**Review of the Abort Dump Shown  
in the SSC Conceptual Design Report\***

J.D. Cossairt  
Fermi National Accelerator Laboratory  
P.O. Box 500, Batavia, Illinois 60510

April 1987

Figure 5.10-10. Abort system external beam dump. The abort dump is a passive sealed unit capable of withstanding indefinitely the 400 MJ of beam energy.

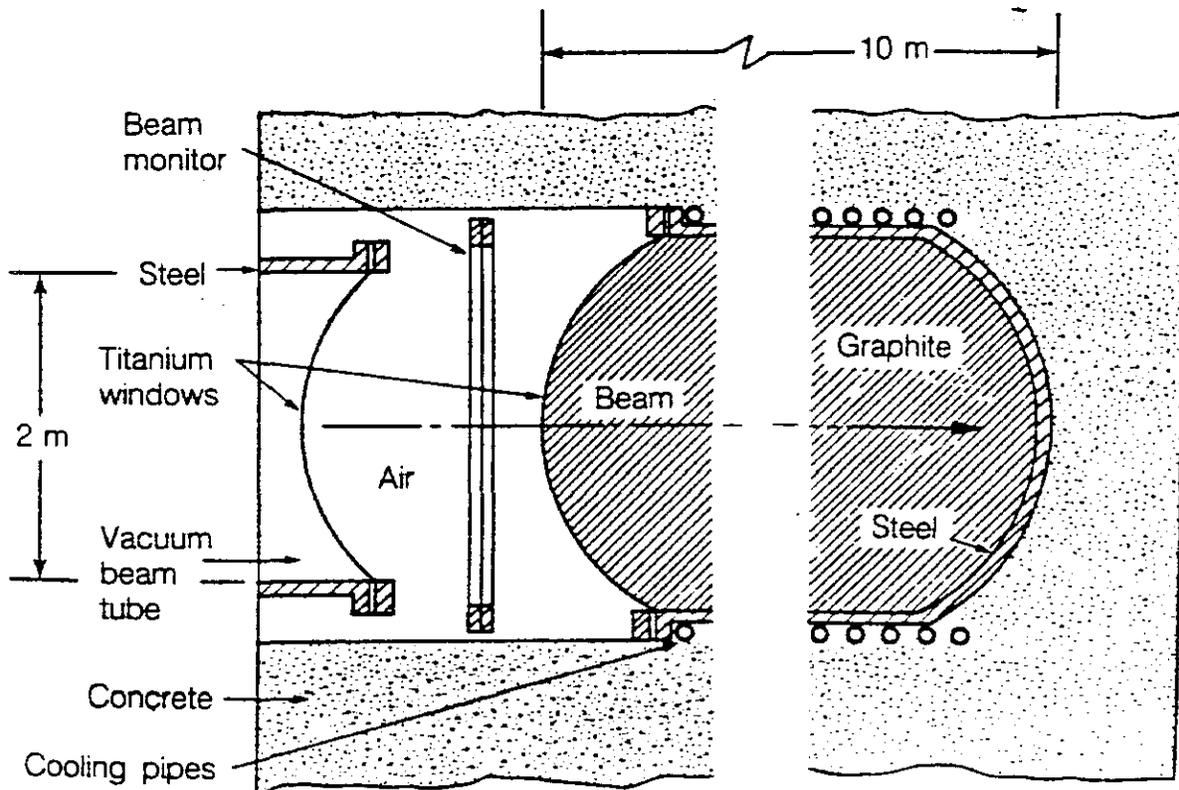
The salient features of interest here are:

1. The dump is located about 1000 meters downstream of dispersing kickers and quadrupoles.
2. It consists of a graphite core surrounded by cooling water loops and concrete shielding.
3. It is about 10 absorption lengths long.
4. It is expected to absorb the 400 MJ due to the dump of  $1.3 \times 10^{14}$  20 TeV protons perhaps as often as 500 times per year. Some aborts, of course, would occur at lower energy.

The first, and perhaps most essential, design concern is that this dump will not self-destruct! Following the CDR, the quads and the drift space spread the beam over an area of  $0.5 \text{ m}^2$  and the shower is largely confined to a length of 3 m located 3 m deep in the shield. This can be checked, and found roughly to be true by looking at the report of Van Ginneken, et.al. (Fermilab FN-447(SSC-106), "Shielding Calculations for Multi-TeV Hadron Colliders") from which the following 3 figures have been copied.
